SERVICE BULLETIN

No. 674

Subject: Rudder Trim Mechanism Modification and Trim Tab Rigging

PA-31T Cheyenne/Cheyenne II
PA-31T1 Cheyenne I

SKETCH "A"

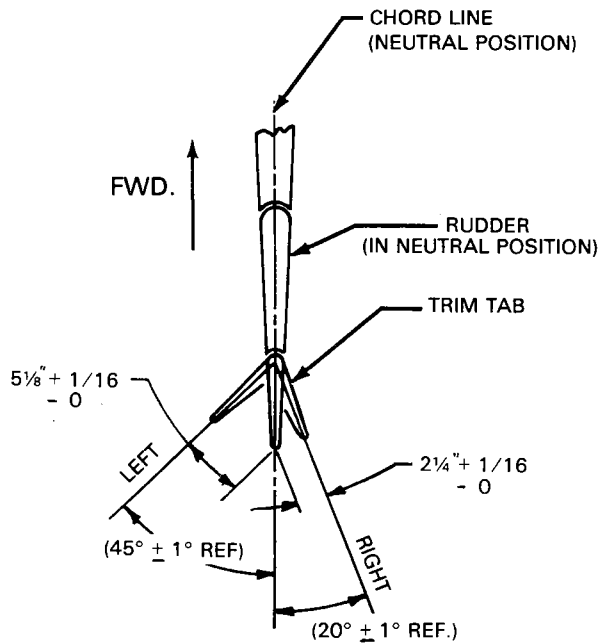
- c. With the rudder trim tab left travel set at $5 \frac{3}{16}$ (46° ref.) install new stop p/n 48437-04 on forward end of trim screw as shown on Sketch "A". Insure stop bottoms against drum housing and insert pin p/n 424 181 (MS20392-2C25). Safety pin to trim screw using wire p/n 151 296 (MS20995-C32) as shown.

SKETCH "B"

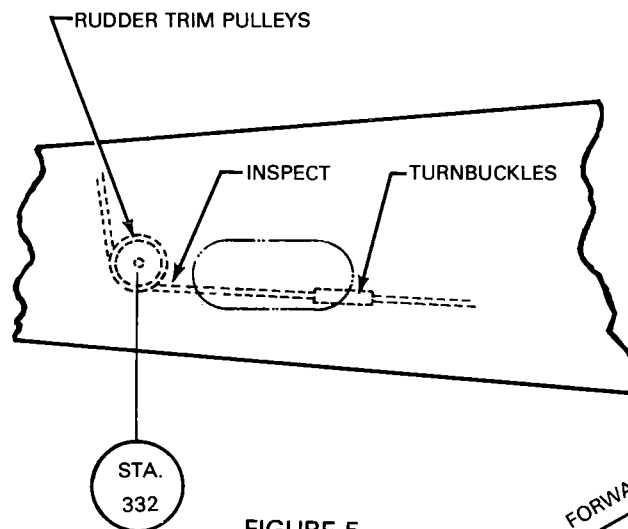
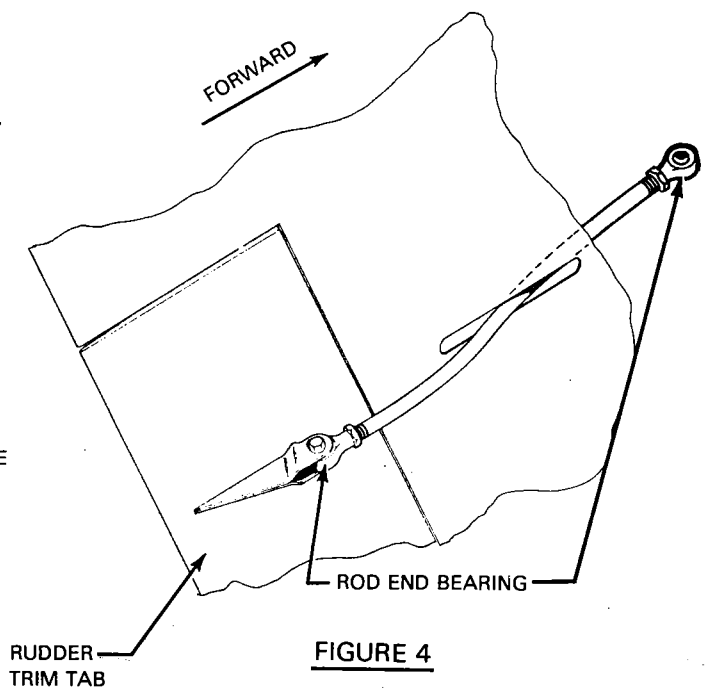
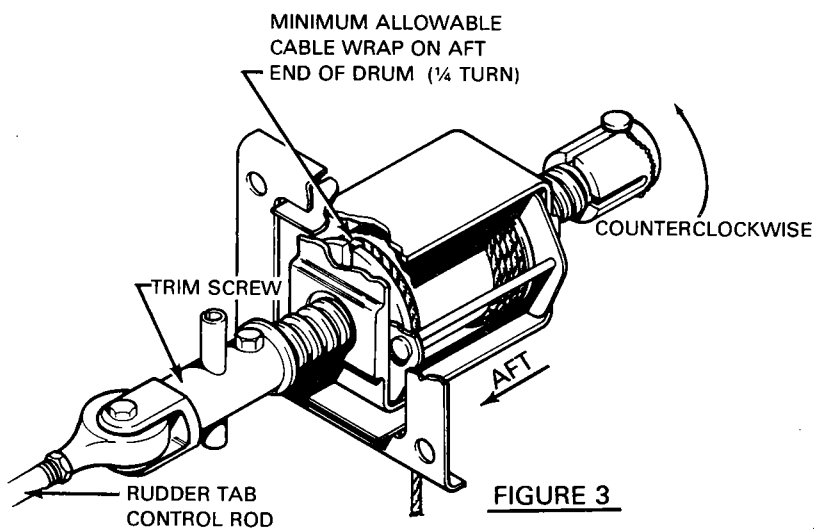
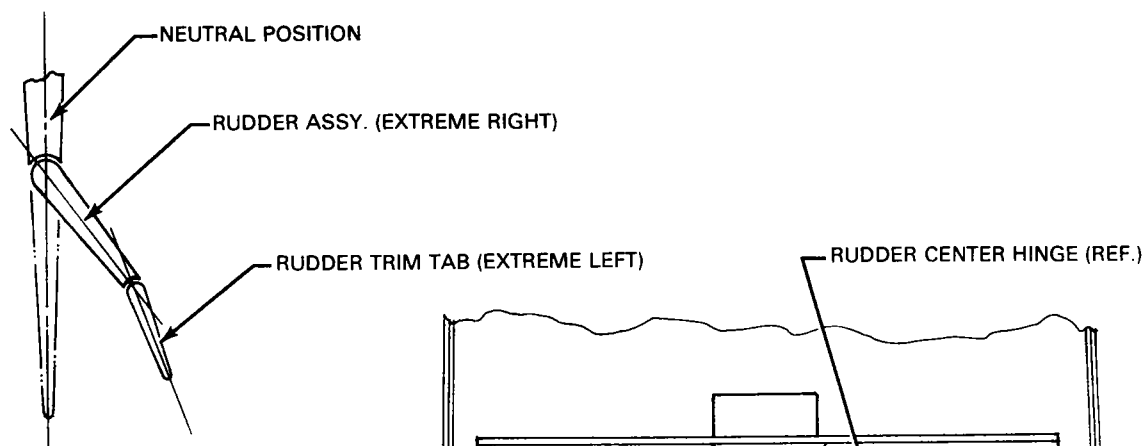
1. Remove the access plate on right side of vertical fin to gain access to the rudder trim screw assembly.
2. Remove and discard the rudder trim screw forward stop and attaching bolt.
3. Refer to Sketches "A" and "B". Check the rudder trim tab for proper travels as follows.
 - a. Position the rudder and rudder trim tab in the neutral position as shown on Sketch "B", Figure 1.

When measuring left and right trim tab travel, linear dimensions must be taken between centerline of rudder trailing edge and centerline of trim tab trailing edge (along bottom of trim tab) as shown on Sketch "B", Figure 2.

- b. Move the rudder trim tab, using trim wheel on pedestal, to the extreme left position and obtain $5 \frac{3}{16}$ (46° ref.) initial travel. Insure at least 1/4 turn of cable remains on aft end of drum as shown on Sketch "A" and Sketch "B", Figure 3.

- d. Inspect the forward rudder trim drum, at pedestal, with trim tab extreme left to insure at least 1/4 turn of cable is remaining.
 - e. Move the rudder trim tab to the extreme right position as shown in Figure 1. Adjust trim tab rod end bearings, per Figure 4, as necessary to attain the $2 \frac{1}{4} \pm \frac{1}{16}$ (20° \pm 1° ref.) dimension.

- g. With the rudder in the neutral position, recheck the trim tab travel dimensions per Sketch "B", Figure 1. Readjust left tab travel to $5 \frac{1}{8} \pm \frac{1}{16}$ (45° \pm 1° ref.) per step 3b(2) if necessary.

FIGURE 5

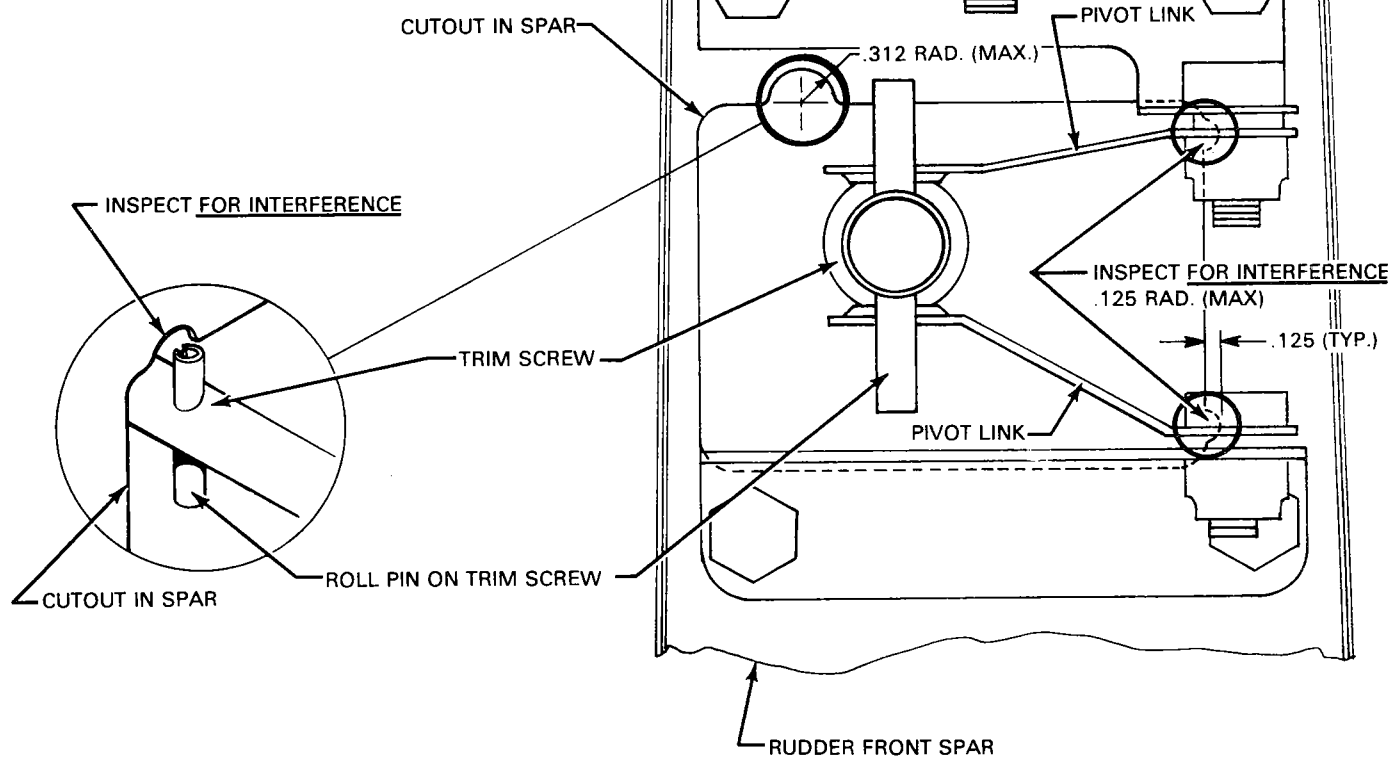
- f. Refer to Figure 5. Remove access plate on right side of fuselage, between sta. 317 and sta. 332. Inspect trim control cables to insure turnbuckles do not interfere with pulleys when trim tab is in the full right position.

SKETCH "D"

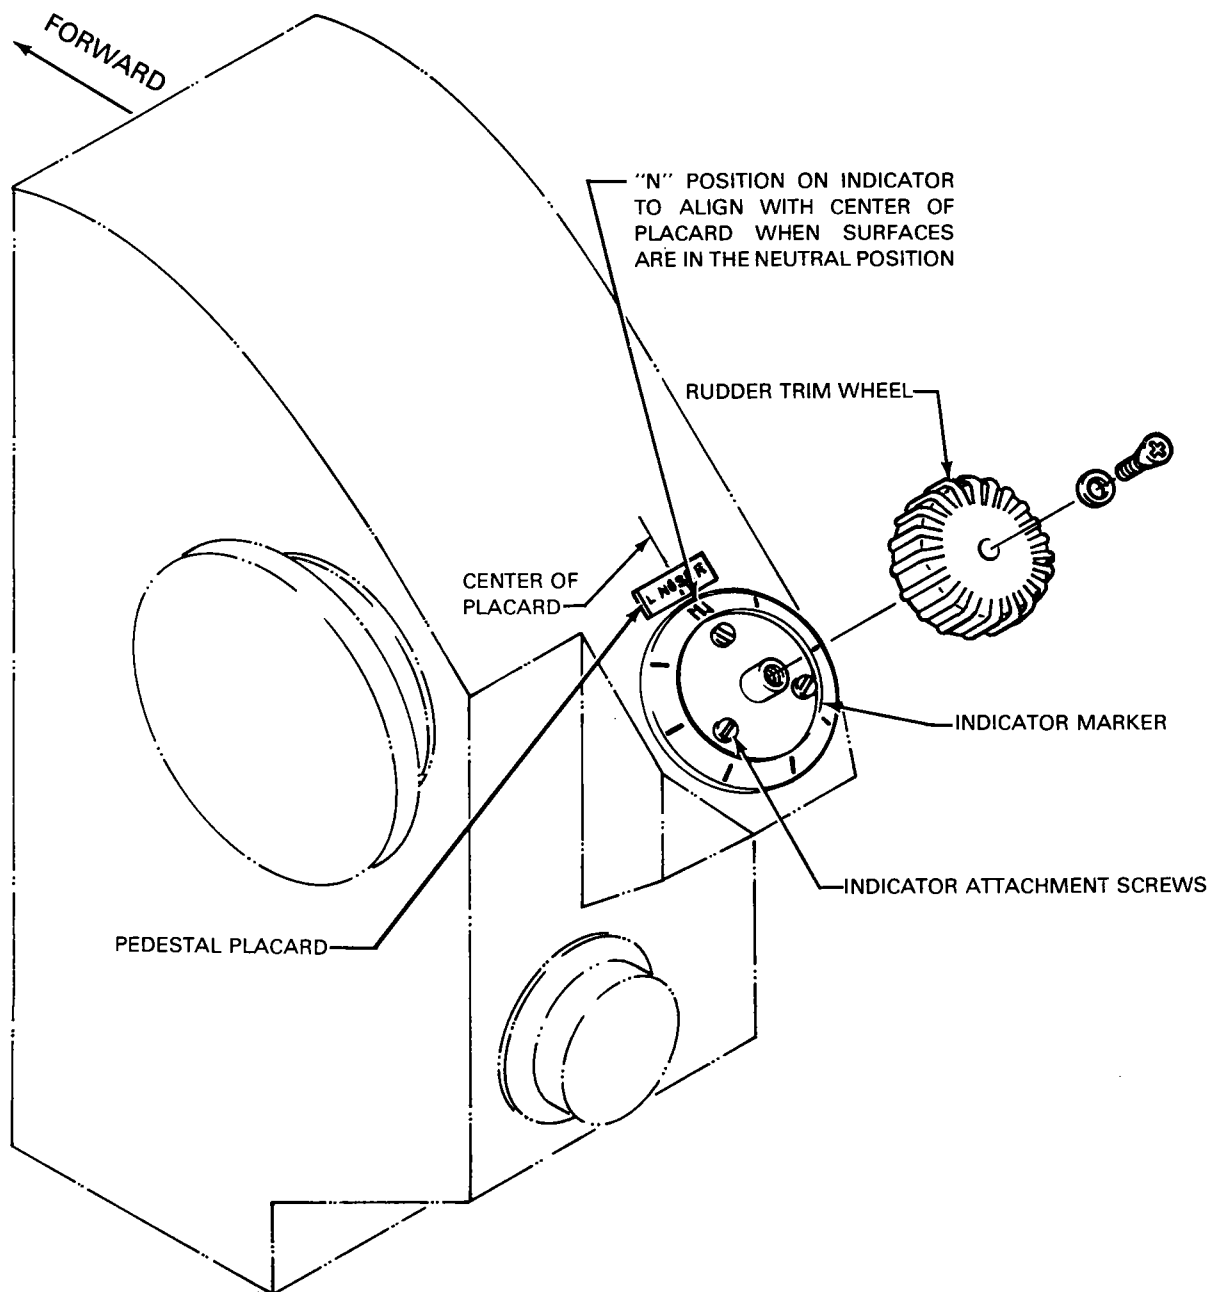
6. Refer to Sketch "D". The rudder trim wheel indicator marker, "N" position, must be aligned with the center of placard on pedestal as shown. If the neutral mark on the indicator does not align with center of placard on pedestal proceed as follows.

- a. Remove the rudder trim wheel from shaft.
 - b. Loosen the three screws which hold the indicator marker to the indicator mechanism.
 - c. Rotate the indicator marker to align the "N" position with the center of placard on pedestal as shown.
